**PG&E Topock
Compressor Station
Needles, California**

**Revised Groundwater Corrective Measures
Implementation/Remedial Design Work Plan
for SWMU 1/AOC 1 and AOC 10**

November 2011

Subject: Revised Groundwater Corrective Measure Implementation/Remedial Design Work Plan for SWMU 1/AOC 1 and AOC 10, PG&E Topock Compressor Station, Needles, California (Document ID: PGE20111104A)

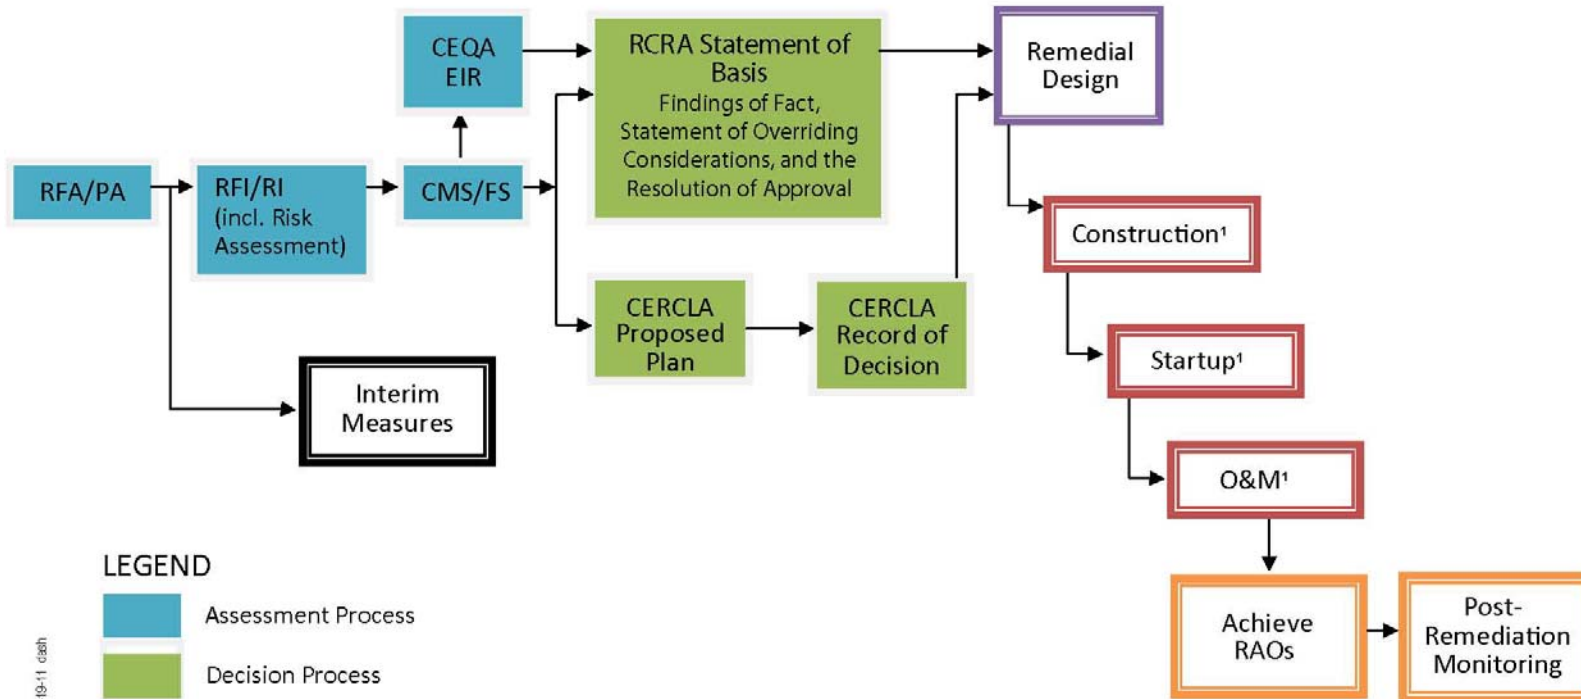
18	HA-2	p. 1-3 (Exhibit 1-1)		Hargis + Associates, Inc. (on behalf of Fort Mojave Indian Tribe)	This exhibit should show how the Tribal consultation process relates to each of the various steps and processes depicted, as requested at the May 2011 TLP meeting.	Figure 4-1, not Exhibit 1-1, was presented and discussed at the May 2011 TLP. Per DOI's direction at the May 2011 TLP and the June 2011 CWG, Figure 4-1 was revised (see attached) to indicate that Tribal Consultation will occur at each step, from design through post-remediation monitoring.	Okay.	Concur with revised Figure 4-1.	Comment noted.
19	DTSC-11	Page 1-4, Remedy Decision, Second Paragraph	"The decision process steps identified on Exhibit 1-1 include the California Environmental Quality Act (CEQA) EIR, the RCRA SOB, the CERCLA Proposed Plan (PP), and the CERCLA ROD."	California Department of Toxic Substances Control	Modify this sentence and remove "the California Environmental Quality Act (CEQA) EIR". EIR is an assessment document for the final decision. Project approval is based on the Findings of Fact, Statement of Overriding Considerations and the signing of the Resolution of Approval.	Text will be revised to say (inserted verbiage shown in <u>underline</u> typeface): "The decision process steps identified on Exhibit 1-1 include the California Environmental Quality Act (CEQA) EIR, the RCRA SOB, <u>the Findings of Fact, the Statement of Overriding Considerations and Resolution of Approval,</u> the CERCLA Proposed Plan (PP), and the CERCLA ROD." Exhibit 1-1 was also revised (see attached) to expand the box "RCRA Statement of Basis" to include Findings of Fact, Statement of Overriding Considerations and the Resolution of Approval.	Okay.		Comment resolved.

EXHIBIT 1-2
 Level of Project Detail Over Time

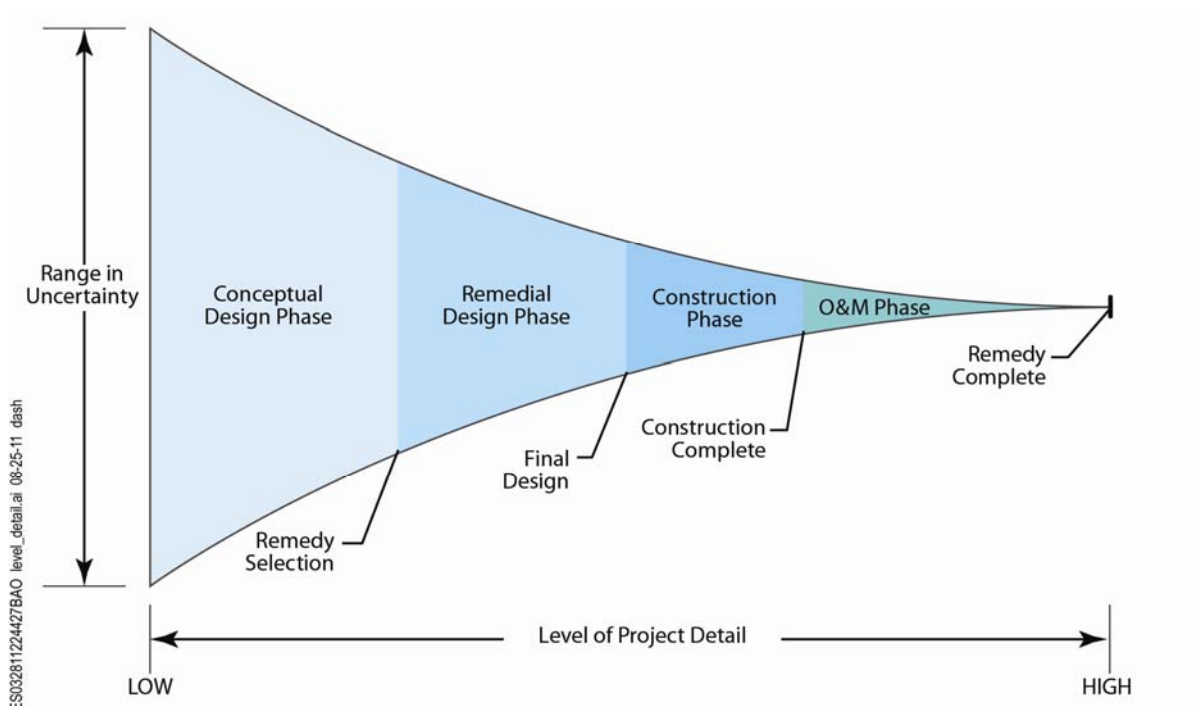
28	DTSC-17	Page 1-5, Last Paragraph and Exhibit 1-2	"The level of project definition will increase during the remedial design phase and will continue to increase during the construction and operation and maintenance phases."	California Department of Toxic Substances Control	The project definition should not change beyond the remedy design phase. The concept of increasing project definition is for cost estimate accuracy (evident by cited reference USEPA, 2000) and not to be confused with remedy implementation. Revision is requested.	The project is expected to change following the remedial design phase. There will be changes made during the construction phase and during the (decades-long) operational phase for a number of reasons, such as to enhance performance, to provide for adjustments due to field conditions or changes in site conditions, to respond to contingency or emergency situations, and to	Okay.		Comment noted.

29	HA-5	p. 1-6 (Exhibit 1-2)	Hargis + Associates, Inc. (on behalf of Fort Mojave Indian Tribe)	This is a conceptual diagram intended to illustrate that the level of project definition increases along the project timeline. However, this exhibit cited from the EPA (2000) guidance document ¹ [See http://www.epa.gov/superfund/policy/remedy/pdfs/finaldoc.pdf] was prepared to illustrate “Expected Cost Estimate Accuracy Along the Superfund Timeline.” The exhibit purports to represent range in uncertainty along the vertical axis, but does not clarify that this represents cost uncertainty and not design or project definition. Instead, as discussed in the bottom paragraph of p. 1-5, this exhibit implies that progress along project timeline somehow decreases the uncertainty about the project definition. This is a circular representation and should be eliminated from the discussion.	Please see response to Comment #28 DTSC-17. The comment is correct that the graphic in the cited cost estimating guidance was intended to represent cost accuracy; however, because cost accuracy is directly related to the level of project definition, this graphic was incorporated (with modifications) into the work plan to illustrate the increasing certainty in the project details that will occur during the design, construction, and operational phases and to communicate the relative level of project certainty at this point (at remedy selection) and at future project phases.	Okay.	Comment noted.	Comment noted.

**FIGURE 1-2
GROUNDWATER REMEDY
PROJECT AREA**

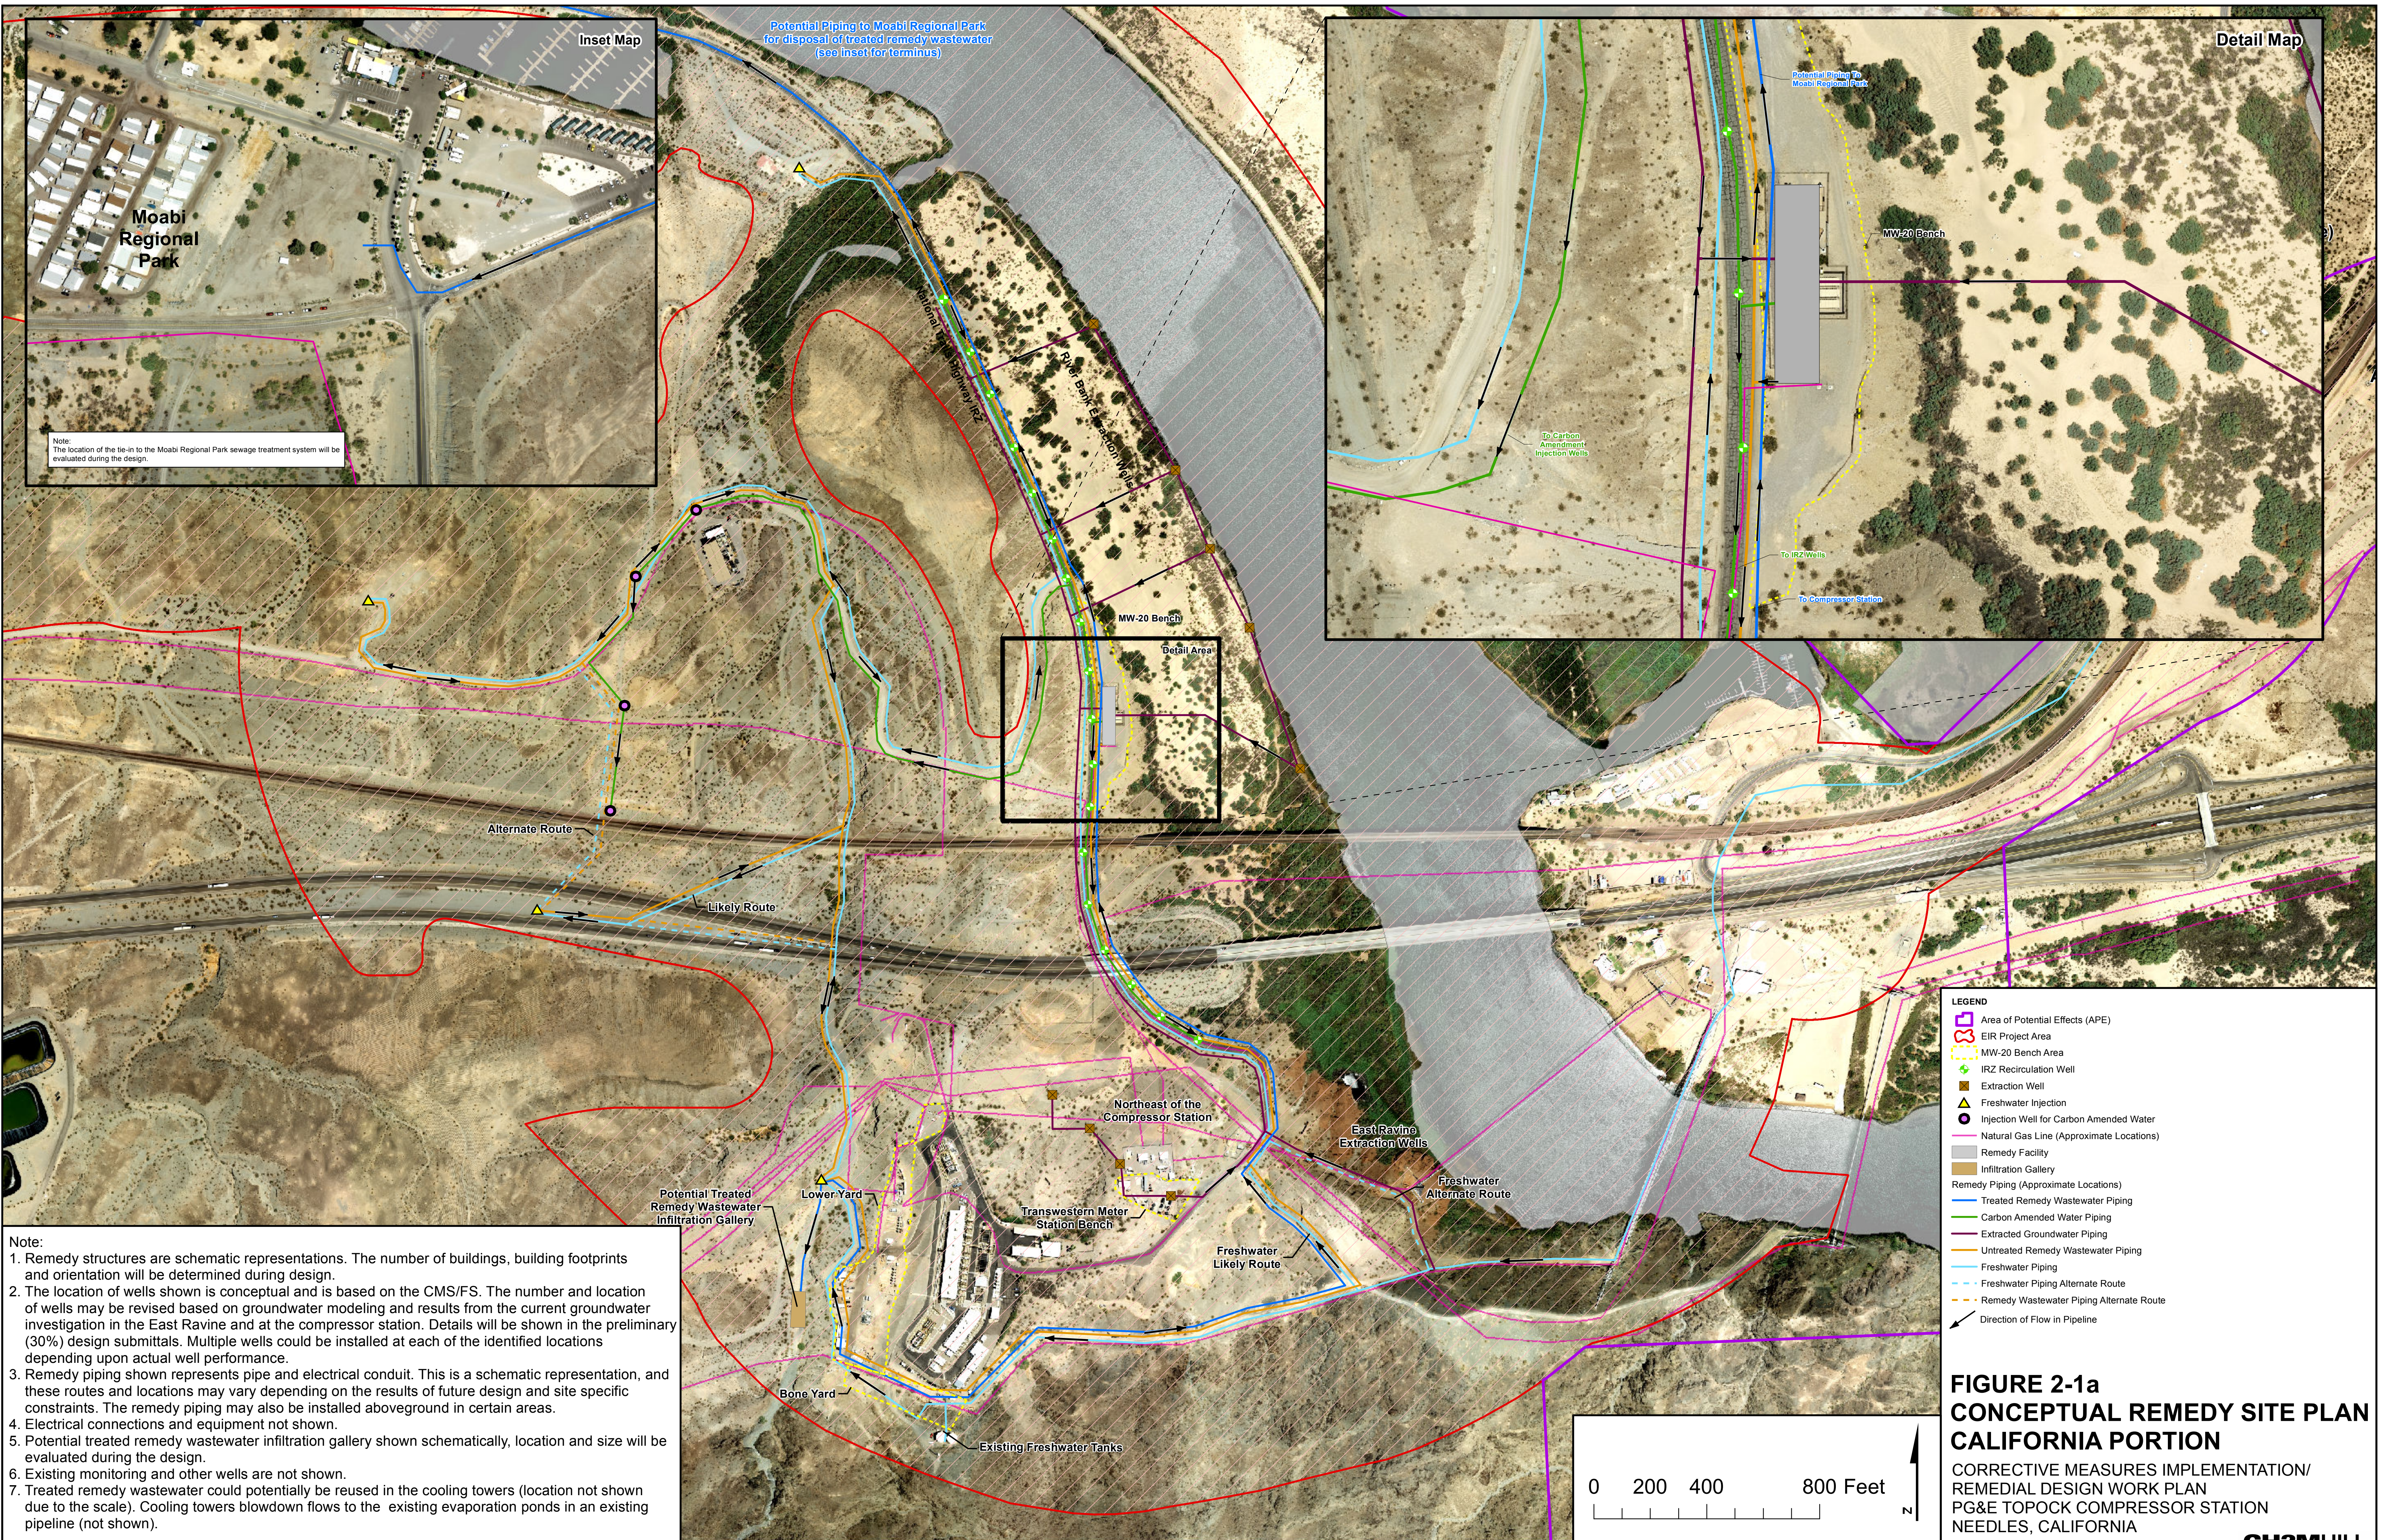
33	HA-6	p. 1-7 (ARARs & Figure 1-2)	Hargis + Associates, Inc. (on behalf of Fort Mojave Indian Tribe)	The last sentence in this section refers to the Area of Potential Effects (APE), as defined by the Programmatic Agreement (PA). ² [The Tribe is not a signatory party to the PA.] Figure 1-2 illustrates the APE as well as the "project area" as defined in the FEIR, prepared pursuant to the California Environmental Quality Act (CEQA). Figure 1-2 does not define the APE as it has previously been defined. Compare Figure 1-2 with Figure 2-2, Volume 2 of the FEIR. The APE in this current document has been extended to the north, to the east and to the west. It also must be noted that the Tribal governments that participated in the PA discussions chose not to be signatory parties based largely on the fact that the PA failed to adequately identify and take into account the direct, indirect, and cumulative adverse impacts to the lands within and outside of the APE. These impacts, which the PA did not consider, are significant and irreversible intrusions to the Tribes' religious and cultural connection to the land. The APE, as shown in the FEIR, Figure 2-2, and in the CMI/RD Figure 1-2 were never presented to the Tribes for comment or consultation. As was pointed out in previous comments, the FEIR only considered the archaeological features of the land, and not the spiritual religious viewpoint of the Mojave people that the project area is within a much broader sacred landscape. Furthermore, Figure 1-2 is misleading as it represents that the so-called "loci" of the Topock Maze are exclusions to the EIR project area and implies that sacred areas are being avoided. The Tribe has commented numerous times that this representation of the "loci" as delineating a sacred area is inappropriate and misleading: The "loci" are only places determined to be archaeologically significant based upon the presence of artifacts. The	Figure 1-2 presents the project area as defined by the EIR and the APE as specified in the PA. PG&E defers to DTSC and DOI on response to the remainder of this comment.	There is no Fig 2-2 in the Volume 2 of FEIR. Nevertheless, the "EIR project area" identified in Figure 1-2 of the CMI/RD work plan is consistent with all Exhibits within the draft and final EIR that identified the proposed project area. The draft EIR was provided to the Tribes for preview between 4/27/10 – 6/4/10 followed by a 45 days comment period between 6/4 – 7/19/2010. The commenter's objection is noted, however, DTSC believes the FEIR did capture the spiritual religious viewpoint of the Mojave people that the project area is within a much broader landscape. See Section 4.4 of the FEIR. PG&E will provide language in the CMI/RD Work Plan regarding tribal cultural ties to the area.	DOI defers discussion related to the FEIR to DTSC. Through continued consultation on each design phase, DOI and BLM hope to further define the measures needed to mitigate or reduce the adverse effects to the TCP.	Comment noted.
